D/DRC Case

1221-1301 Huger Street & 401-433 Gervais Street

DESIGN/DEVELOPMENT REVIEW COMMISSION
DESIGN REVIEW DISTRICT
EVALUATION SHEET
Case #3

NATURE OF REQUEST: Request for Certificate of Design Approval for Building One and Building Two

LANDSCAPE PLAN

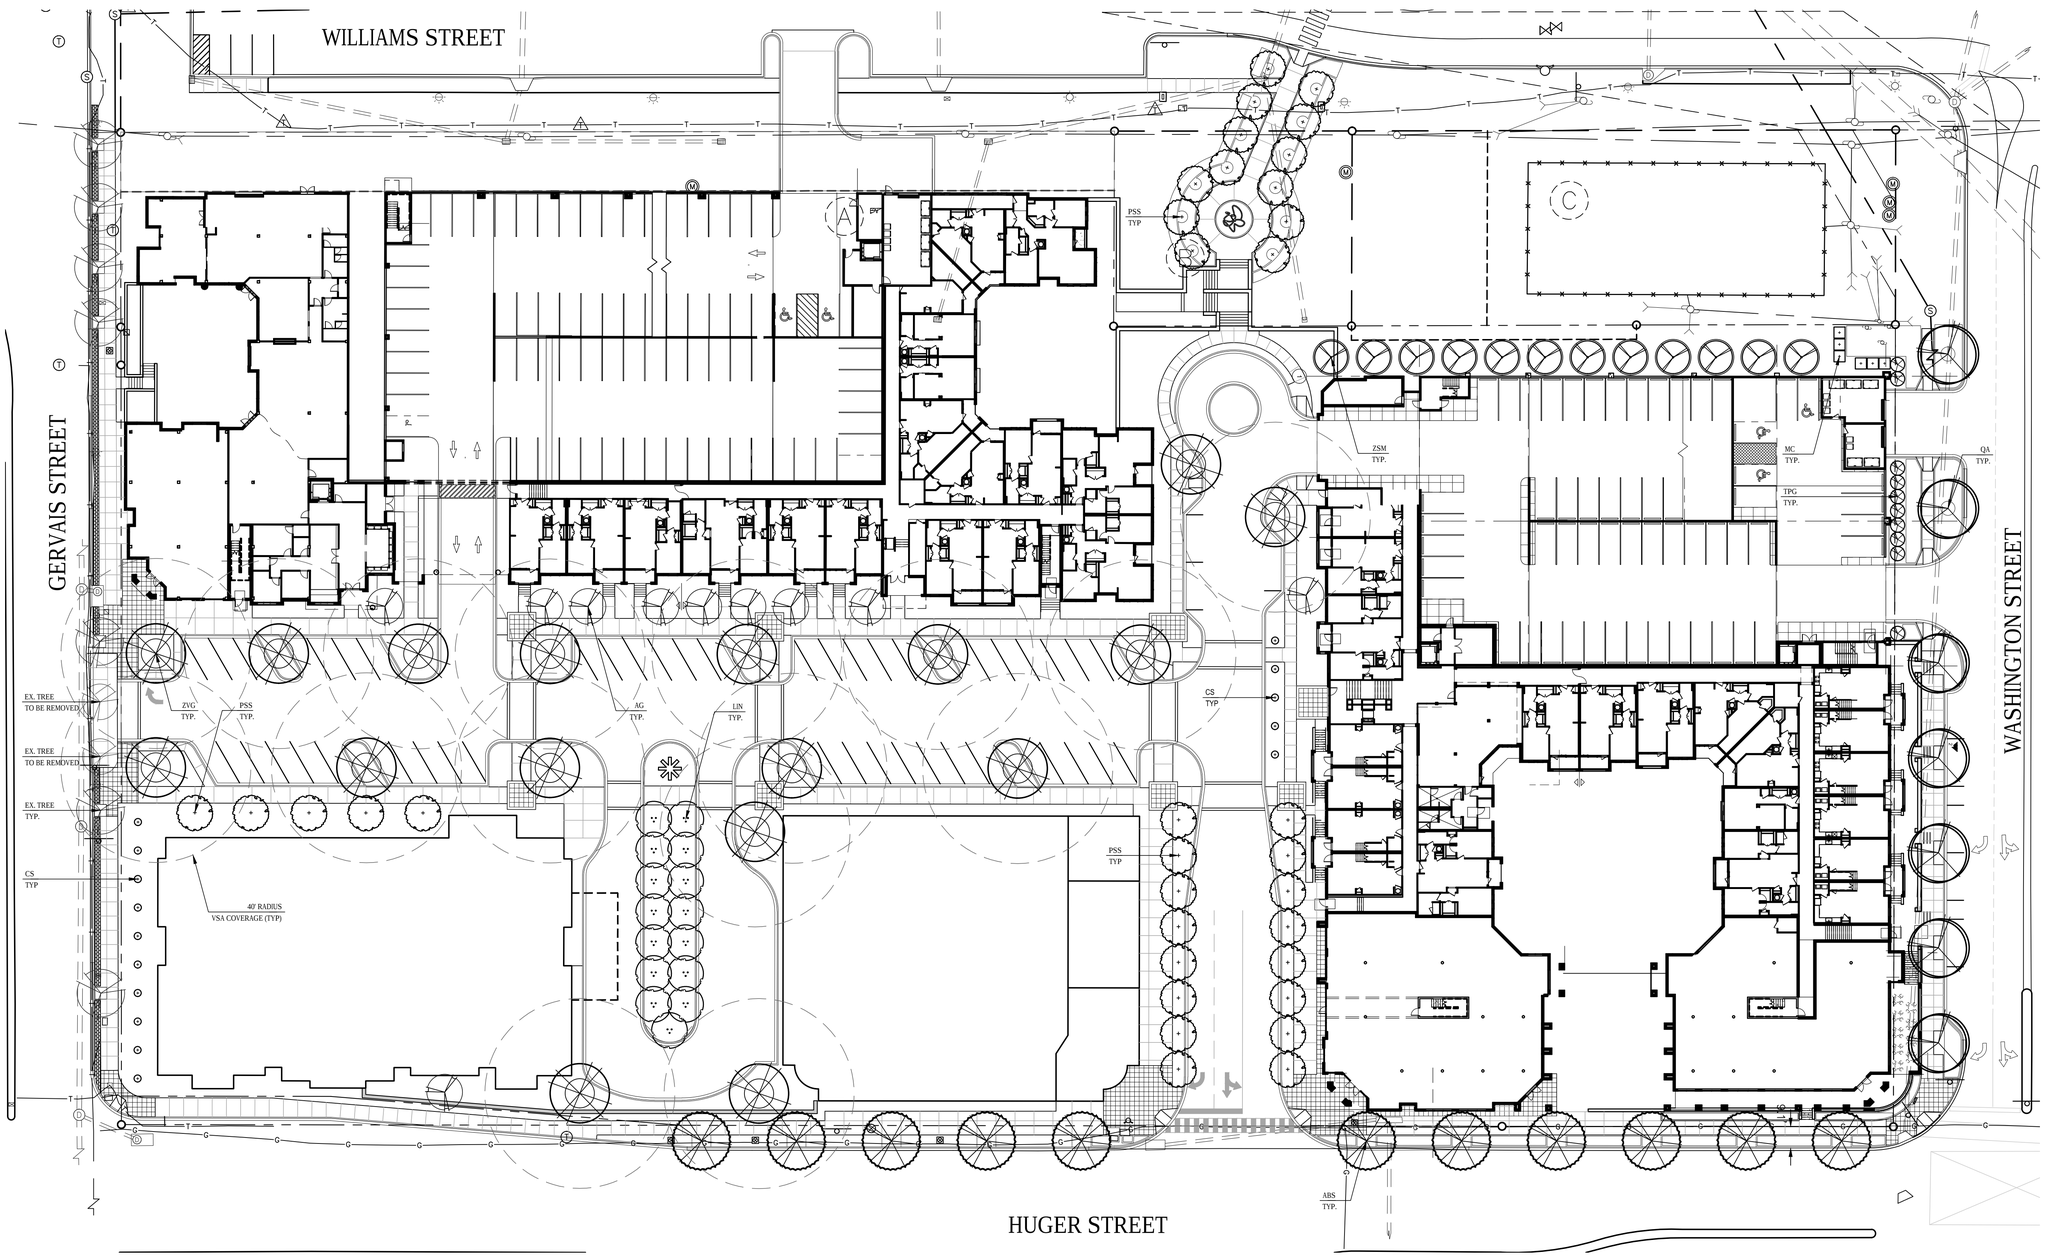
Generally, the streetscapes will be designed to meet the City standards with regard to site furnishings, lighting, paving, street trees and irrigation. Lots of this will be reviewed in detail as part of the site plan review process and also the encroachment process, which includes review per the urban design guidelines and also the landscape ordinance. One concern from a pedestrian comfort and aesthetics standpoint is that there could be more shade trees along the sidewalks. Many of the proposed street trees are small flowering trees, and could be alternated with larger shade trees. As well, the pedestrian connection and turn-around circle at the end of Lady Street should incorporate maximum shade for the pedestrian.

- Per *Section 5.6 Landscaping,* that there be shade trees added to the streetscape to provide pedestrian comfort.
- Per *Section 5.7.1 Storefront Composition, Accessories, and Details,* and detailing be added to the building at street level,

WEST ELEVATION - OVERALL 2

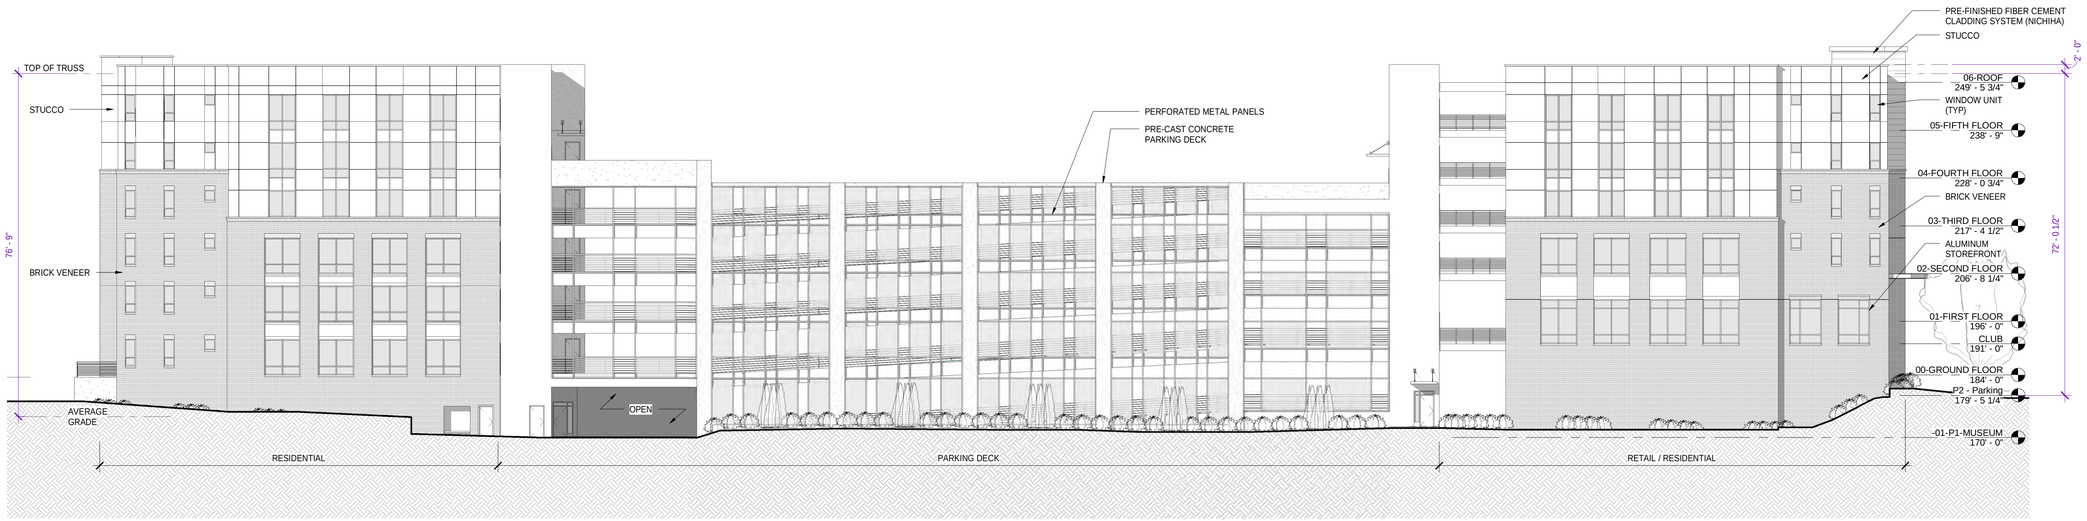
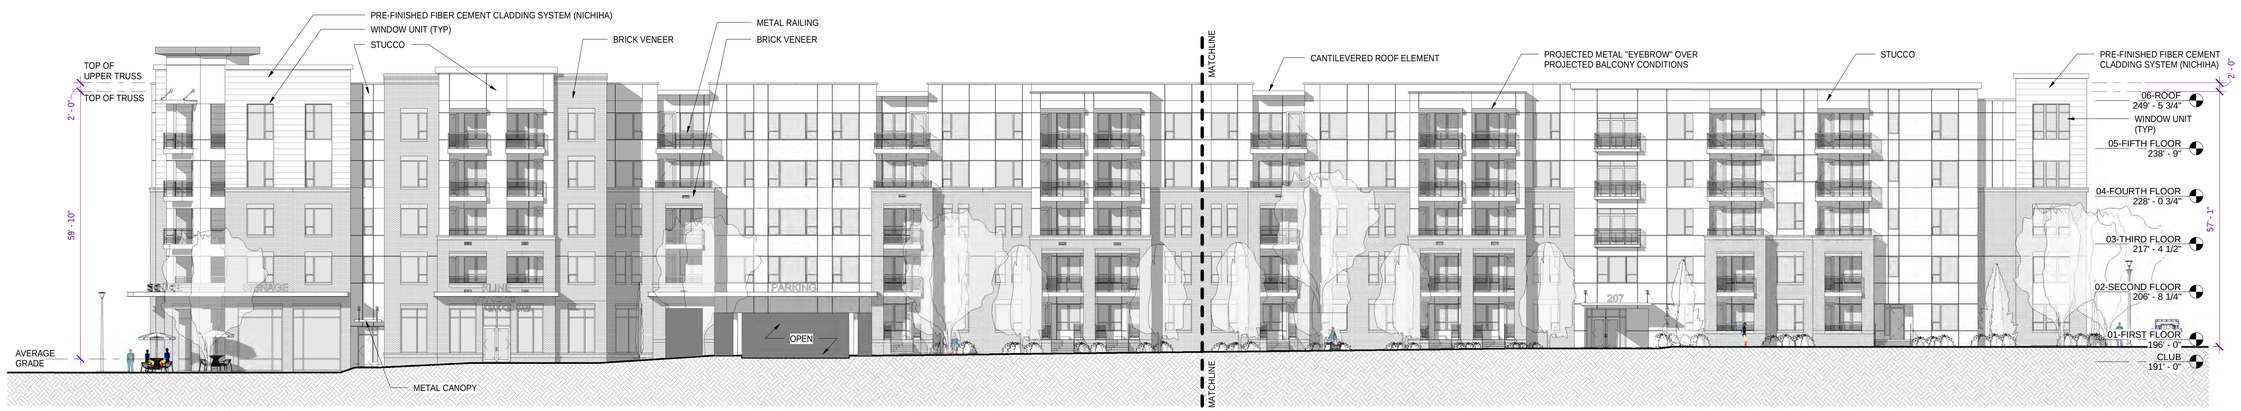
Building Two generally needs more street-level detailing, and architectural elements to add interest to the façade. The Gervais Street elevation has blank walls for nearly 100 feet, with windows and courtyard about nine feet above the street level. A terraced planter has been added in front of the residential courtyard, which helps mitigate the height of the wall, but overall more detailing is needed. The canopies on this end are 25 feet above the sidewalk. Similarly, on the retail end the storefront is largely flat and unarticulated, and the western-most canopy of the retail section is nearly 20 feet above the sidewalk, which seems too high to create a sense of human scale.

The residential portion of Building Two, on the eastern elevation, with recessed entries slightly above grade and steps to the sidewalk is well articulated. The retail portion on the Gervais Street end is relatively flat. The north elevation is all residential; a better understanding of how the courtyard/grade change from Lady Street is treated would be helpful. Again, this will ultimately be very visible and travelled by pedestrians as a primary east/west connection.

MATERIAL STUDY AT PARKING GARAGES

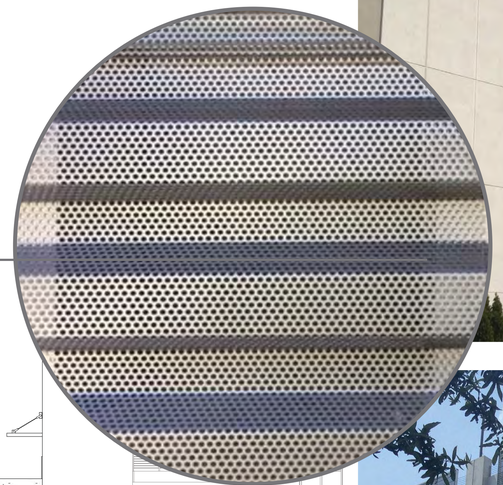
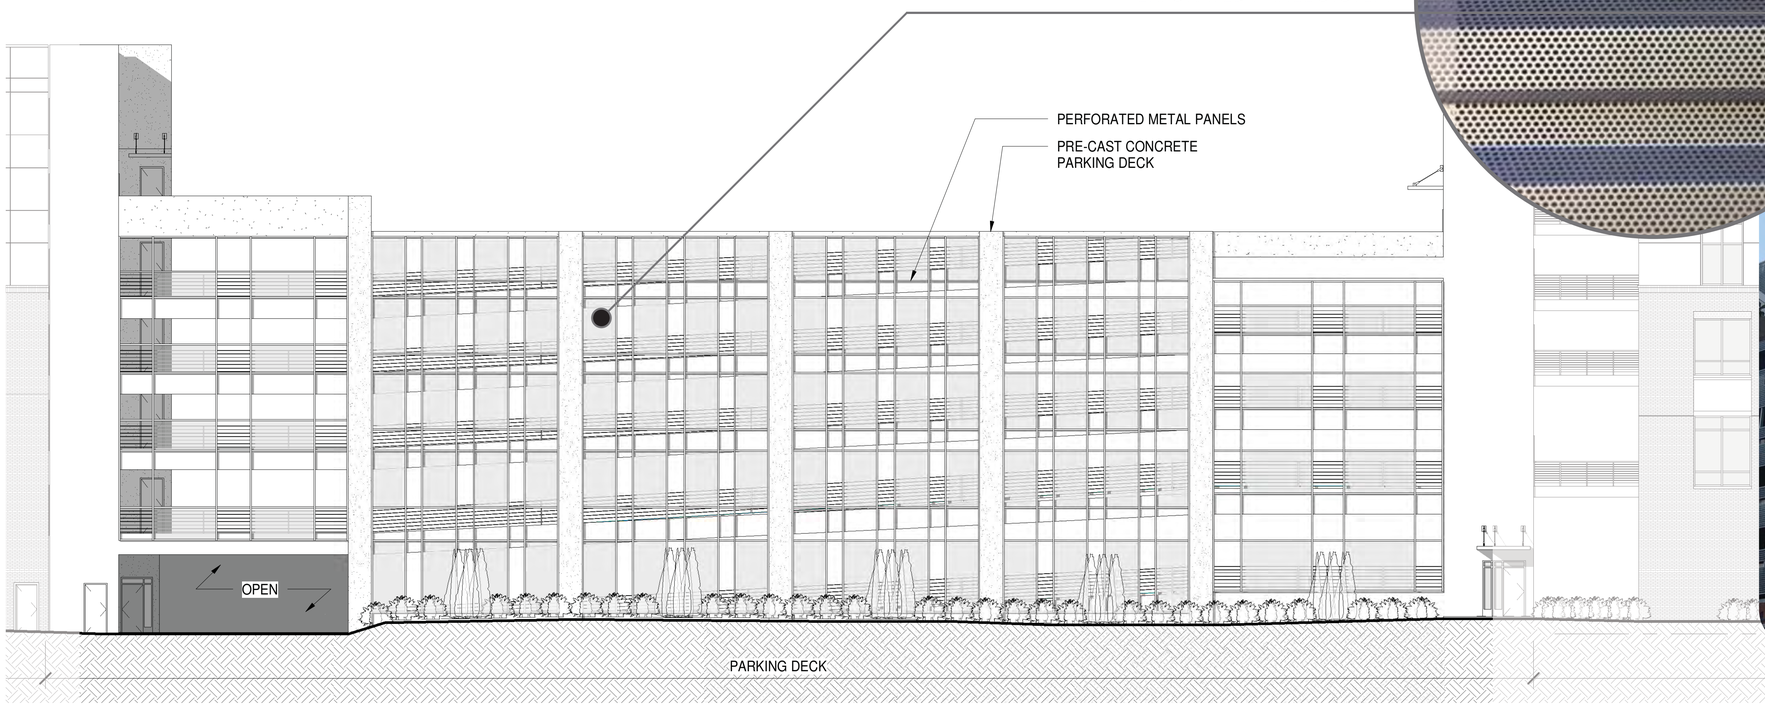
The primary materials of both mixed-use buildings are brick, hard-coat-stucco, and fiber-cement architectural wall panels (Nichiha). Detail elements include concrete canopies at the first level, metal canopies and eyebrows at the upper level, and metal railings throughout. More information is needed about material selections, colors and details. The applicant will be submitting materials boards and samples as requested. The parking garages are pre-cast concrete with perforated metal screen panels. More information is needed about the materials and screening of the garage.

- Per *Section 5.10.1 Structured parking,* that the parking garage design be developed to ensure a high-level of finish and screening of vehicles and ramping,
